Flood Risk Assessment and Drainage Strategy Addendum Report

Proposed Residential Development of Land at Eakring Road, Bilsthorpe

Document Type: Flood Risk Assessment and Drainage Strategy – Addendum Report

Project Number: 19017

Appendix A: Drainage Strategy – drawing number 8B

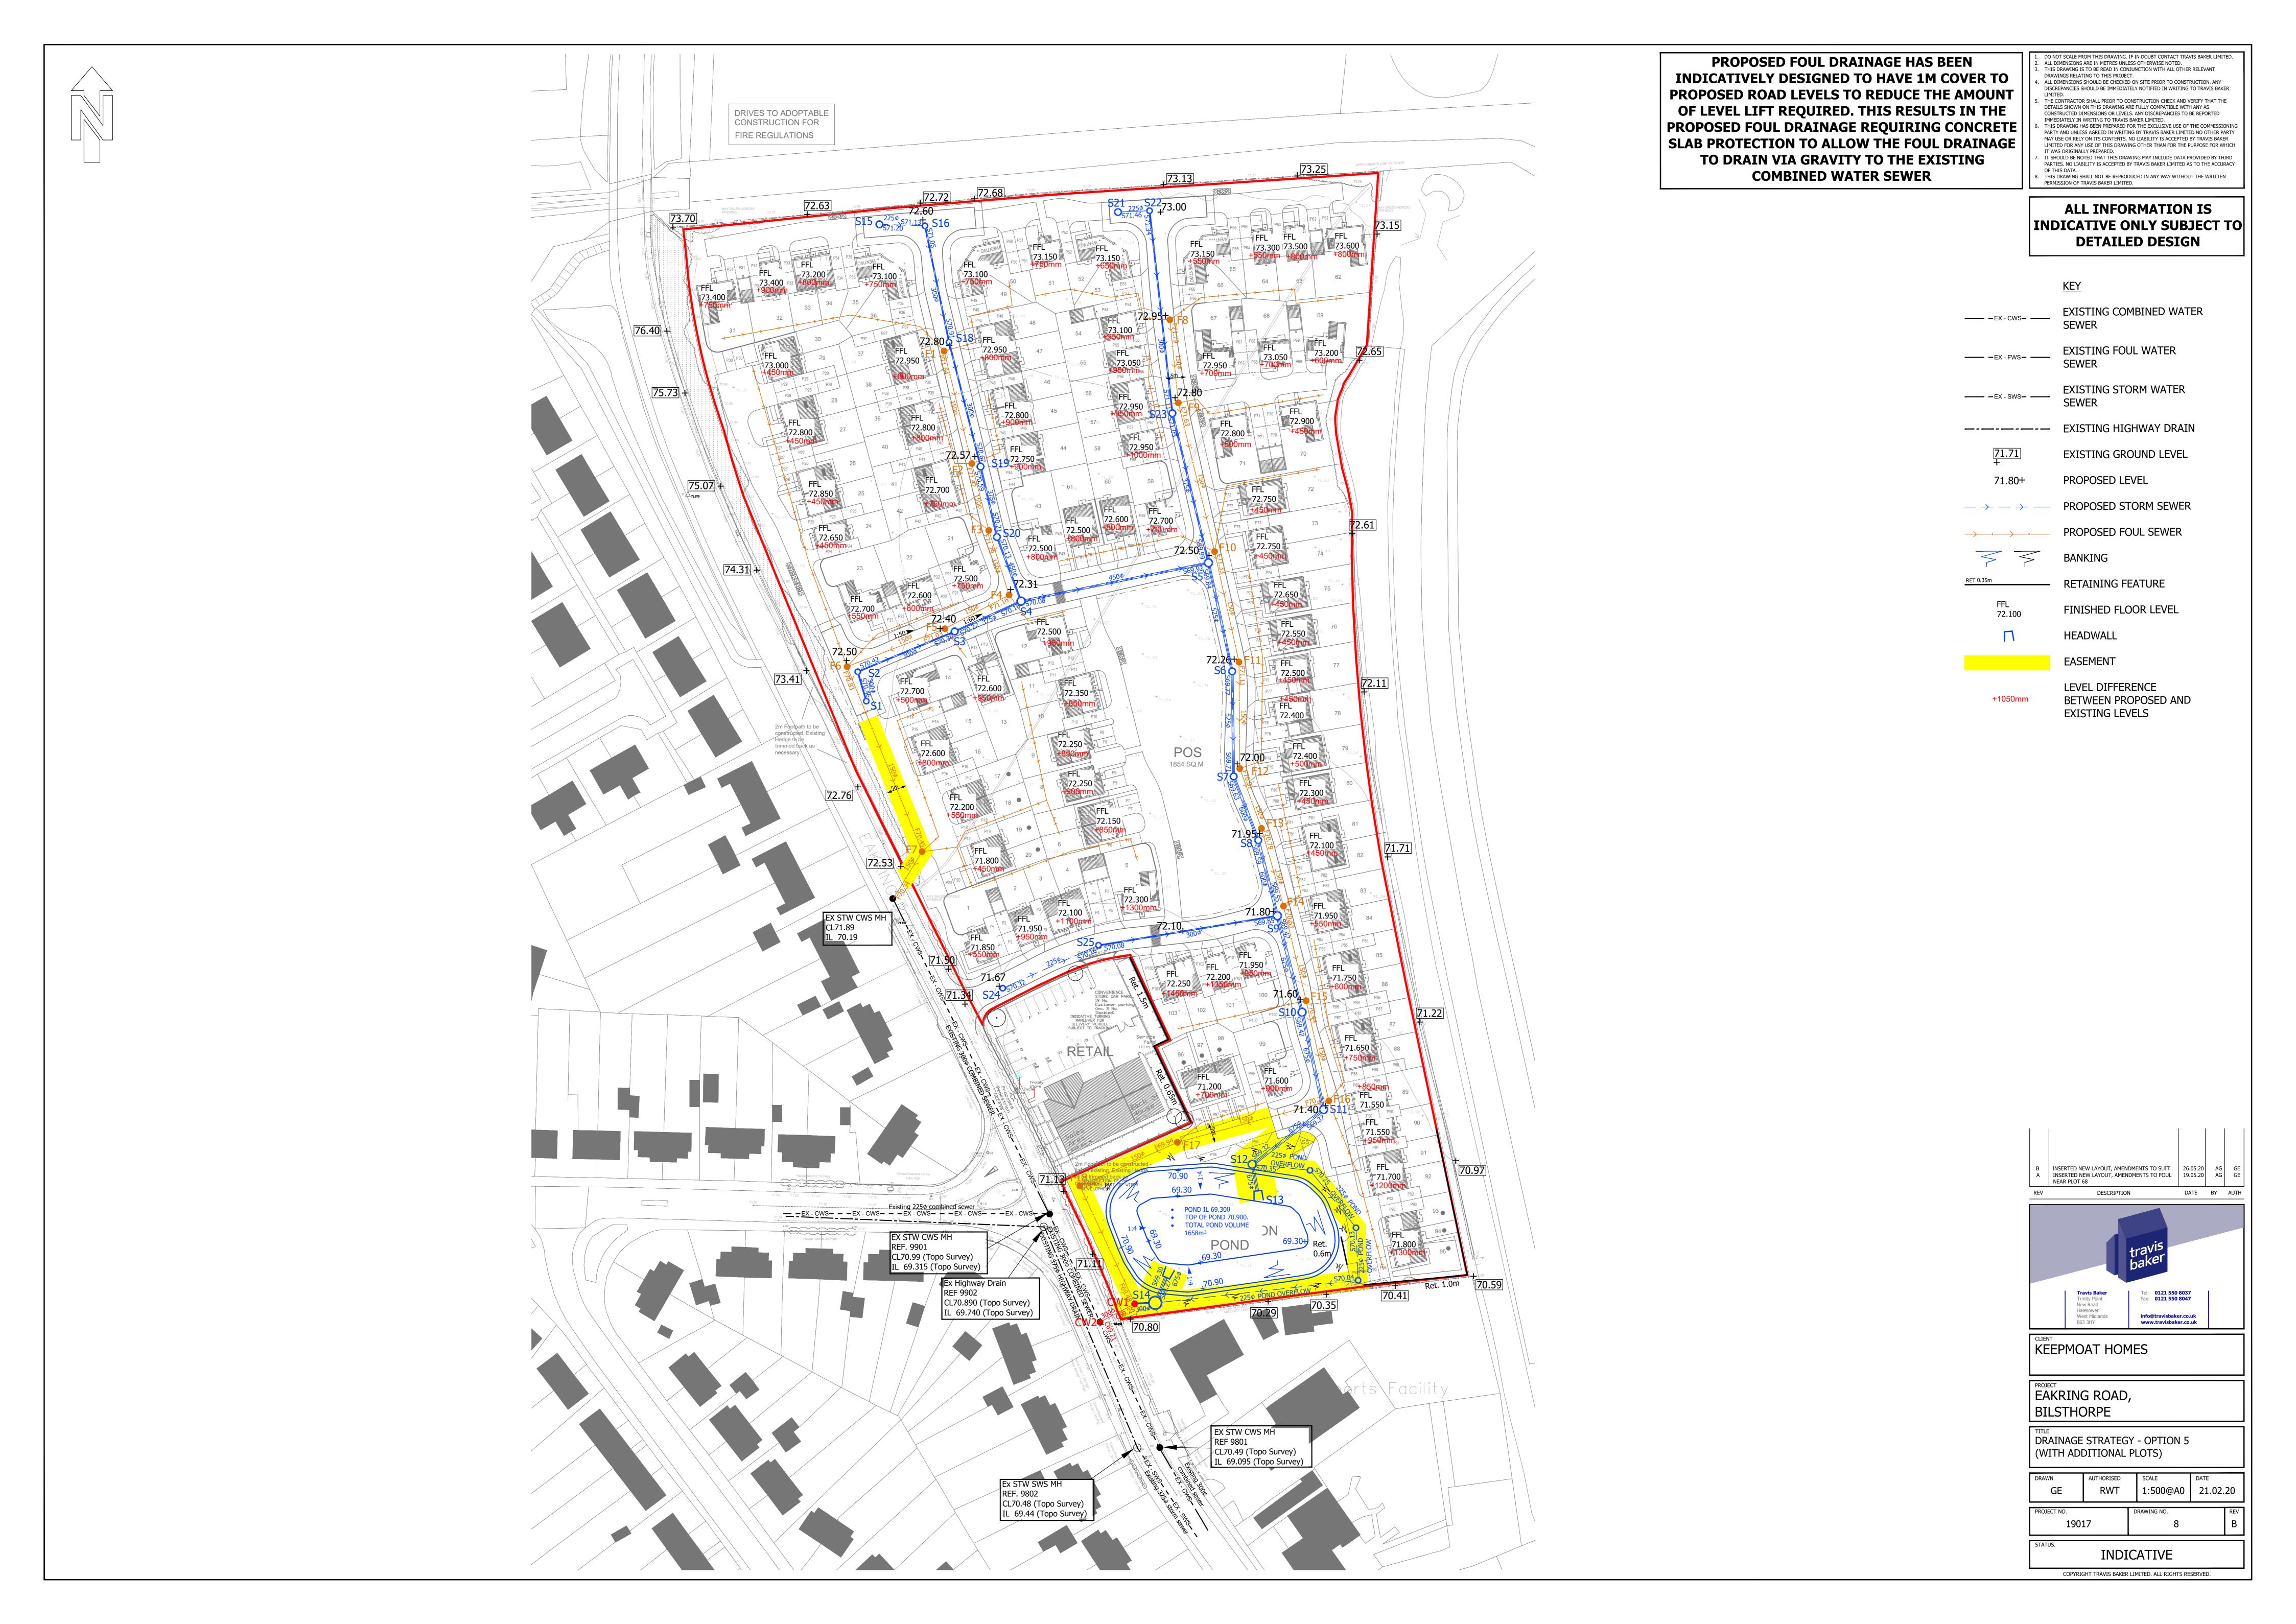
- 2.1.1 Details of a proven outfall from site in accordance with the drainage hierarchy the following options should be considered, in order of preference: infiltration, discharge to watercourse, discharge to surface water sewer or discharge to combined sewer.
- Evidence the maximum discharge is set to the QBar Greenfield run-off rate for the positively 2.1.2 drained area of development.
- Show the SUDS systems will be incorporated into the surface water management scheme for 2.1.3 the site, preference should be given to above ground SUDS which provide multi-functional benefits.
- 2.1.4 Details of who will manage and maintain all drainage features for the lifetime of the development will be required prior to construction.

- 2.2.1 Infiltration tests were carried out as part of the Geo-Environmental Assessment Report, and as stated in paragraph 6.9.7 most of the site exhibits poor soil infiltration rates and that materials are unlikely to be considered suitable for soakaway drainage. There are no watercourses within or near the site boundary. The surface water sewers are proposed to drain into a public combined water sewer drain at the south west corner of the site. The foul is split into two networks, one that drains to the combined sewer in the mid-western part of the site and the other half to the south western corner with the proposed storm drainage. There are no existing foul water sewers in the vicinity of the boundary.

- 2.2.2 The calculated Obar value per hectare is 0.3l/s, however this is too small a value to be practical for a flow control device without risk of blockage. Severn trent has stated an acceptable discharge rate for the site of 5l/s/ha. The site has an impermeable area of approximately 1.6Ha resulting in an allowable discharge rate of 8l/s. However, we have approached this conservatively and limited the discharge rate to 5l/s.

- 2.2.3 A pond is used for the above ground SUDS systems of the site.
- 2.2.4 A management company for the pond will be selected nearer the build completion date.
